**N° 10296AERRA**

**Errata sheet V1.8 affecting products TC37x\_AA**

**Subject** Errata sheet V1.8 affecting products TC37x\_AA

Rel. 1.8, 2021-11-04

**Figure 2** Message buffer transfer from Message RAM to OBF

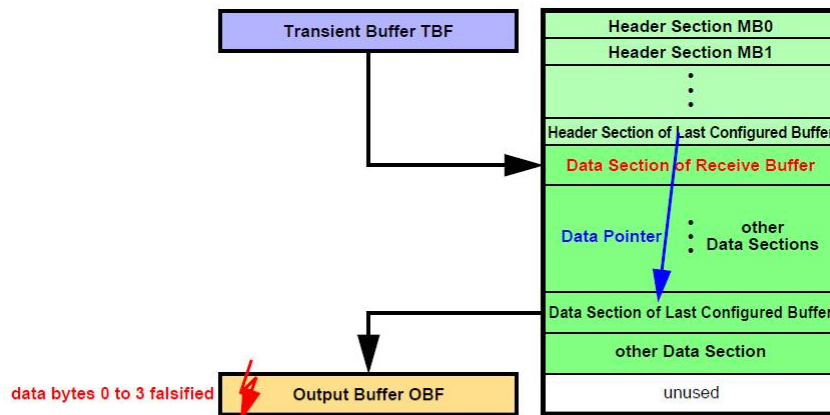
When the message buffer has its payload configured to maximum length (**PLC = 127**), the OBF word on address 00h (payload data bytes 0 to 3) is overwritten with unexpected data at the end of the transfer.

a) When a message is transferred from the Last Configured Buffer in the Message RAM to the OBF and **PLC** = 127 it may happen, that at the end of the transfer the OBF word on address 00h (payload data bytes 0 to 3) is overwritten with unexpected data (see [Figure 2](#)).

**Figure 3** Message buffer transfer from IBF to Message RAM

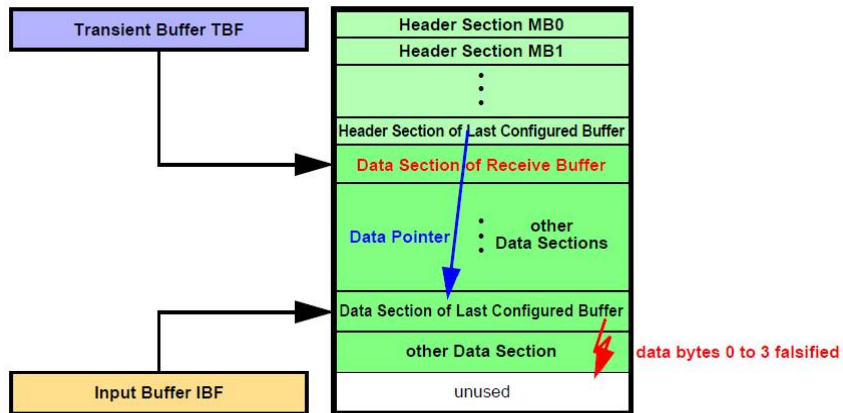
After the Data Section of the selected message buffer in the Message RAM has been written, one additional write access overwrites the following word in the Message RAM which might be the first word of the next Data Section.

b) When a message is transferred from IBF to the Last Configured Buffer in the Message RAM, it may happen, that at the end of the transfer of the Data Section one additional write access overwrites the following word, which may be the first word of another message's Data Section in the Message RAM (see [Figure 3](#)).

Figure 4 Message RAM Configurations

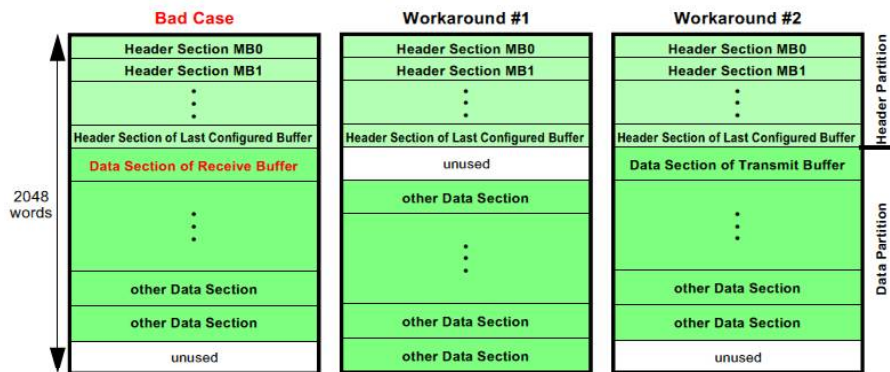
The erratum is limited to the case when (see [Figure 4](#) “Bad Case”):

2) Ensure that the Data Section directly following the Header Partition is assigned to a transmit buffer.

**Figure 6 MCS AEI master access path**

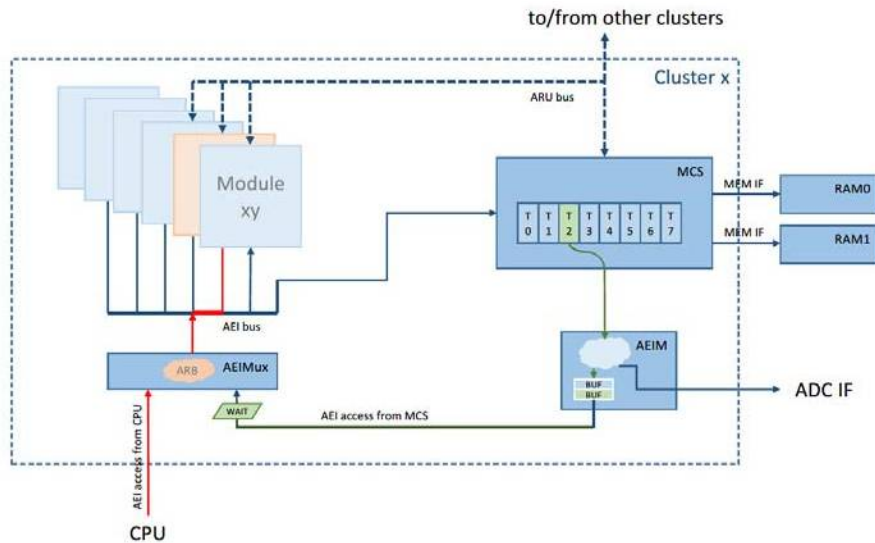
**Figure 6** shows an uncritical traffic situation. Here an access of a MCS thread to the AEI bus (green access path) is temporary delayed due to an ongoing AEI bus access from the CPU (red access path). The MCS access to the AEI bus will be safely buffered at the AEIM (green buffer). As soon as the CPU access to the AEI bus completes, the buffered AEI bus access from MCS will be executed.

**Figure 7 Critical MCS AEI master scenario**

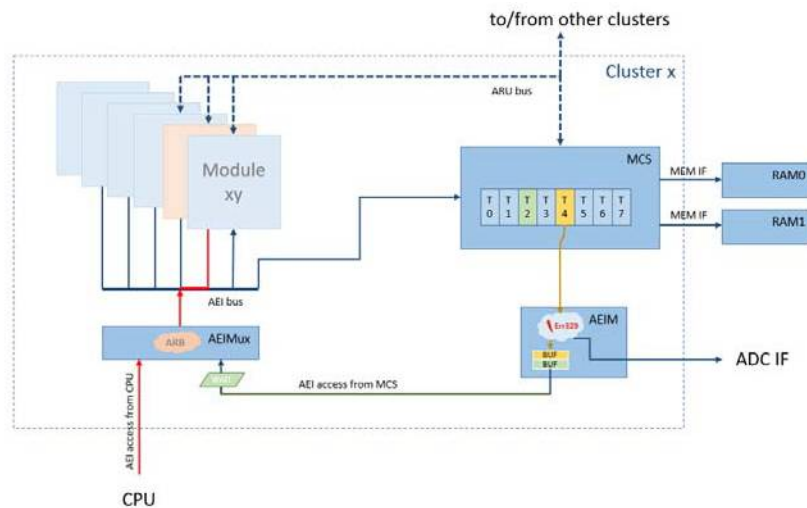
In [Figure 7](#), a potential risk for the occurrence of problem GTM\_AI.329 is illustrated. Here the first buffer of the AEIM (green) is still waiting for the access to the AEI bus while a second AEI bus access from MCS arrives at the AEIM (yellow access path). Under certain, but for the user unpredictable timing conditions, this second AEI bus access arriving at the AEIM can trigger the misbehavior described in problem GTM\_AI.329.

The workarounds described in the following section will ensure that not more than one AEIM buffer will be filled and therefore the occurrence of problem GTM\_AI.329 is avoided. All workarounds have been tested and proven correct.

**Figure 8** MCS token mechanism

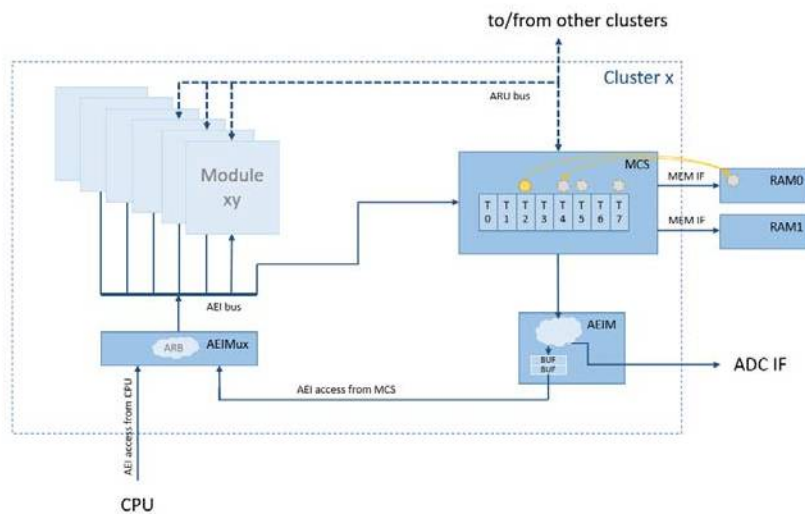
In case multiple MCS channels want to use the AEI master port for AEI or ADC communication, establish a mechanism that ensures that only one channel uses the AEI master at a time (e.g. exchange a token between channels or use trigger registers to hand over the AEI master port ownership between MCS channels).

An application note (AN020 – MCS Mutex implementation) describing a token exchange mechanism between MCS threads is available at Bosch. Such a token mechanism allows multiple MCS threads to safely access the AEI bus system by exchanging an AEI bus access token via MCS memory.

Figure 9 Equivalent Circuitry for Analog Inputs

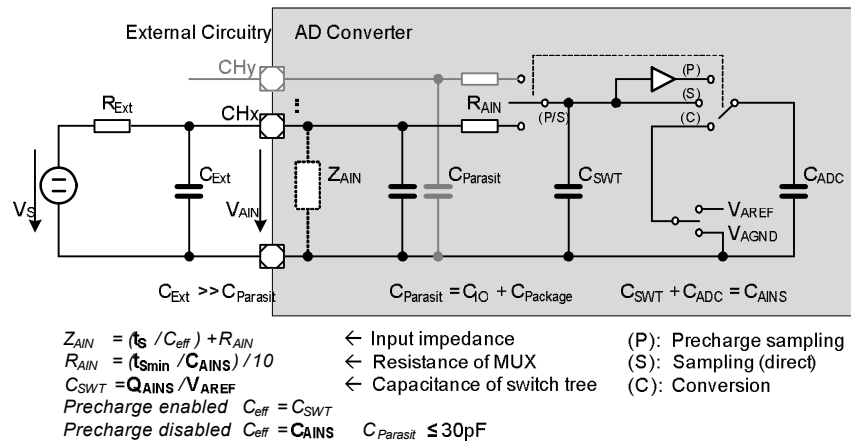
Figure “Equivalent Circuitry for Analog Inputs” will be modified in future revisions of the Data Sheet, including the term  $C_{\text{Parasit}} \leq 30$  pF, as shown in the following figure:

**Figure 10 Interrupt Level vs. Pulse-Notify mode - Corner Case Example**

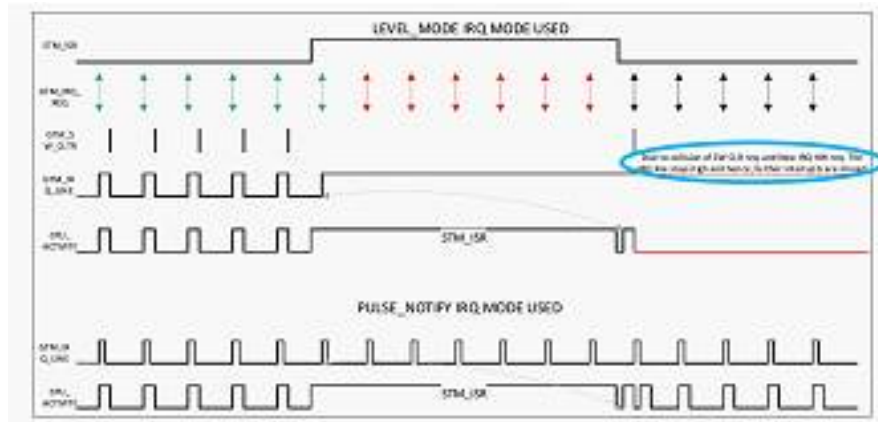
Hence, in Level Mode, in some scenarios where another interrupt request is generated by GTM while the ISR handle also requests a SW clear, then, as the interrupt event is dominant over the clear event (for simultaneous interrupt and clear events), GTM\_IRQ\_XXX is not cleared and remains high. As a consequence, the IR observes no transition on GTM\_IRQ\_XX. Thus, any forthcoming interrupt events in this scenario are lost as there is no chance to release the CPU IRQ when a collision happens as shown in Figure below.

If Pulse-Notify mode is selected, every internal trigger will be forwarded to the IR, irrespective of the time of occurrence and the clear event, as the pulse-notify leads to set and reset of GTM\_IRQ\_XXX as compared to only setting of the GTM\_IRQ\_XXX line in Level mode.

**Figure 12 Timing of LVDS TX interface command sending in relation to IRQ.IFCFS**

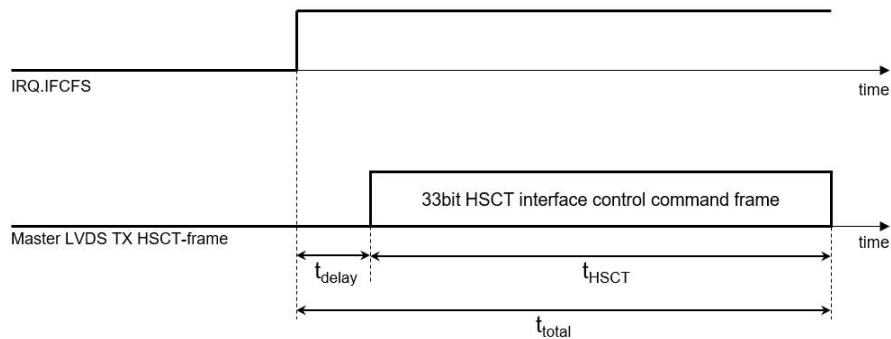
the user might falsely assume that also the actual sending on the LVDS TX port has already occurred once the IRQ.IFCFS flag is set, which is not true.

Instead the timing shown in [Figure 12](#) applies.
